# Product Change Notification (PCN)

PCN #: 11B-2021

DATE: 25<sup>th</sup> November 2021

### 5.1 Back Product Label (on device)

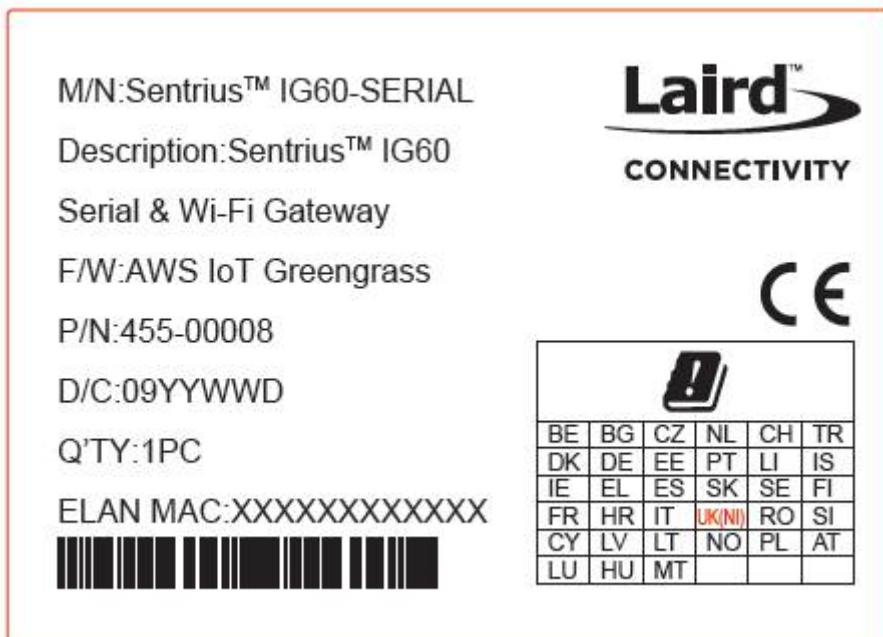
- Addition of UKCA logo on the back product label, where it can be accommodated.
